**Service Letter #:** SL21 66-47200

**Part/Assembly #:** 66-47200

**Float Model Affected:** Aerocet Model 6650 floats

**Affected:** Hydraulic Pump Motor

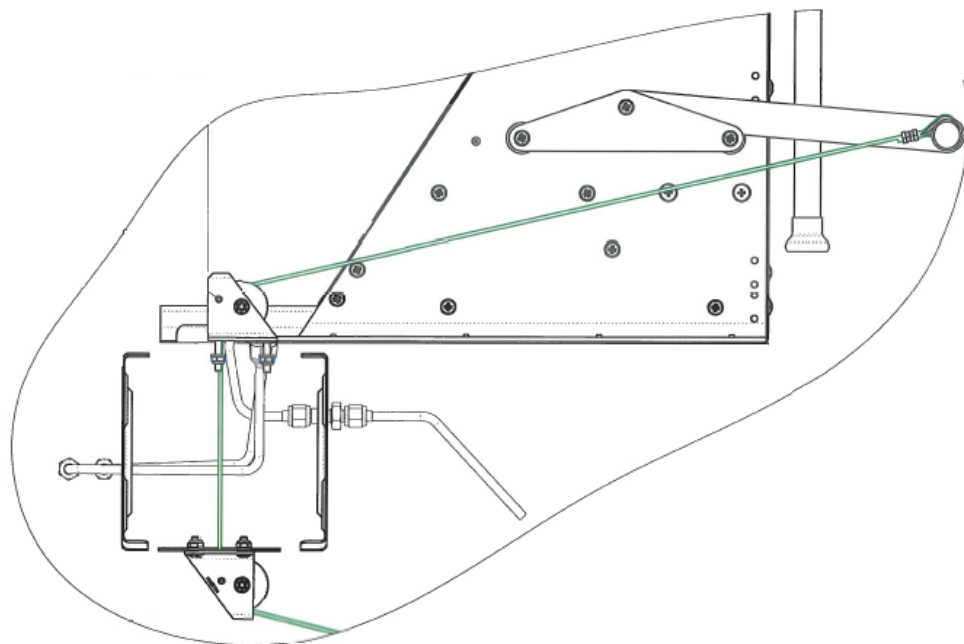
**Reason for Change:** Premature gear wear

**Corrective Action:** Remove and replace hydraulic pump motor.

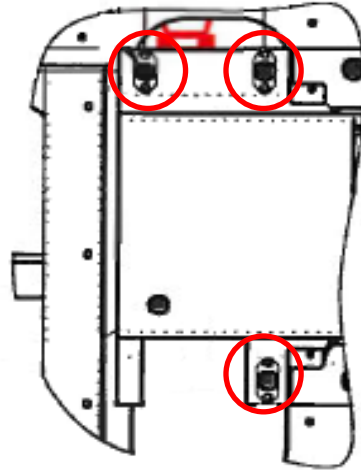
1. Aerocet is sending to you part # 66-47200 which is the complete pedestal, hydraulic assembly so that you will not experience significant down time.
2. Recommend moving pilot seat full aft or removing altogether for easy access.
3. Remove cable from water rudder retract handle.

Caution: Weight of rudder will need to be lessened to ease removal.

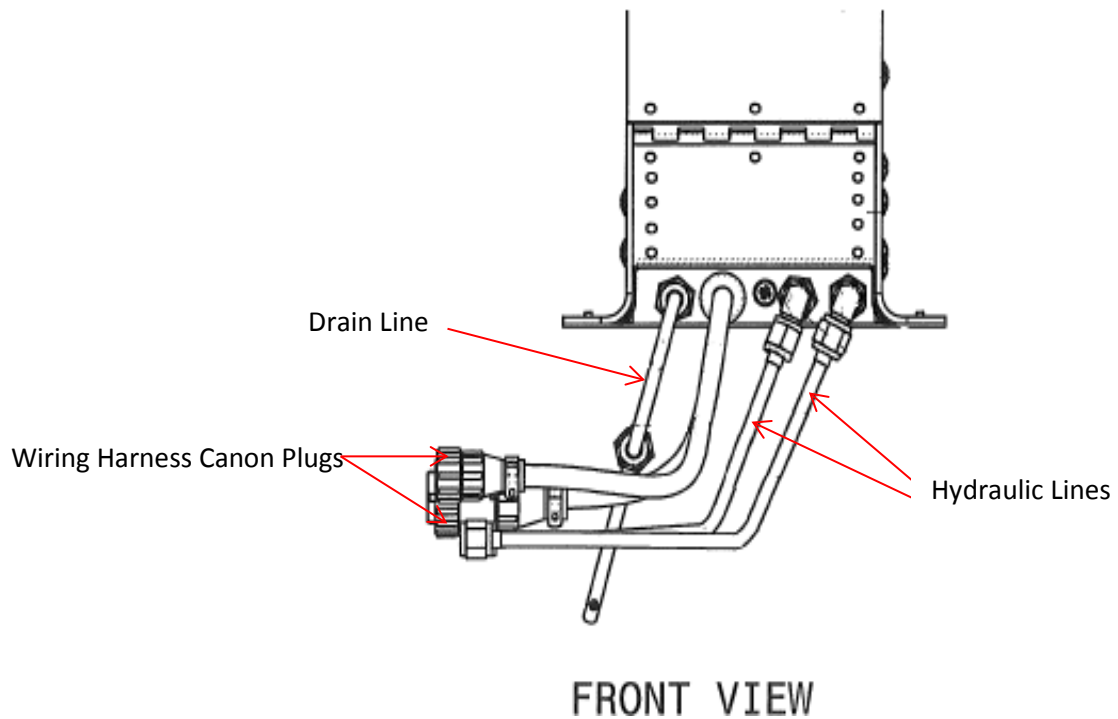
4. Remove 3 screws from hydraulic shield.

5. Remove 4 screws from pedestal base.

6. Disconnect 2 hydraulic lines and one drain line from front of pedestal.  
Cap and plug as necessary.
